# UNITED STATES PATENT AND TRADEMARK OFFICE

10/018,303	10/30/2001	Osamu Sakai	10059-400US (P23013-01)	4864
------------	------------	-------------	----------------------------	------

<b>Office Action Summary</b>	<b>Application No.</b>	<b>Applicant(s)</b>	
	10/018,303	SAKAI ET AL.	
	<b>Examiner</b>	<b>Art Unit</b>	
	Raymond Alejandro	1745

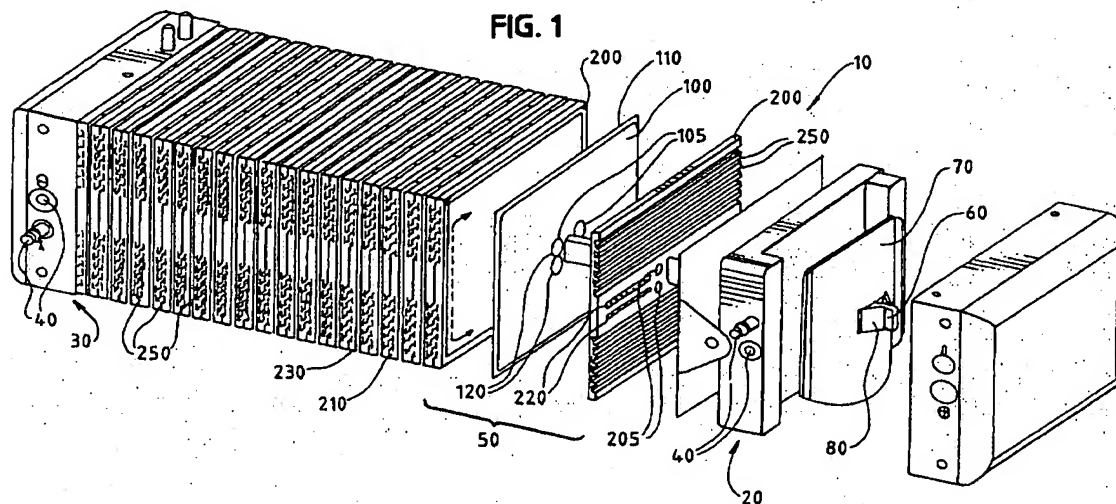
Barton et al disclose an electrochemical fuel cell stack with an improved compression assembly (TITLE). Figure 1 illustrates a solid polymer electrochemical fuel cell stack 10 including a pair of end plate assemblies 20 and 30, and a plurality of stacked fuel cell assemblies

50, each comprising an MEA 100, and a pair of flow field plates 200 (*the flow field plates are also known in the art as separators*) (COL 7, lines 64-67). As illustrated in Figure 1, each MEA 100 is positioned between the active surfaces of two flow field plates 200. Each flow field plate 200 has flow field channels 210 on the active surface thereof (which contacts the MEA) for distributing fuel or oxidant fluid streams to the active area of the MEA 100 (COL 8, lines 23-33). In the illustrated embodiment, flow field plates 200 have a plurality of open-faced parallel channels 250 formed in the non-active surface thereof (COL 8, lines 34-39).

It is disclosed that an elongate tension member extends between and through the end plate assemblies 20 and 30 to retain and secure stack 10 in its assembled state. It is further disclosed that spring plate 70 along with end plates 20 apply a compressive force to fuel cell assemblies 50 of stack 10 and act as restraining members (COL 8, lines 1-7). *It is apparent from Figure 1 above that the end plate assemblies 20, 30 form a gap therebetween so as to accommodate the fuel cell units in a sandwiched arrangement (that is, the end plate assemblies are spaced apart so as to dispose between the two of them the fuel cell units).*

*It is also apparent from Figure 1 above that a laminated and compressed configuration is formed when all components of the solid polymer fuel cell stack with a compression assembly comprising the tension member and a spring plate acting as a unitary resilient restraining member are put together. That is, they all become united into a single unit by compression means and/or a single unit is made by uniting or holding together superposed layers of the MEA, the separator (fluid flow field plate) and the end plates.*
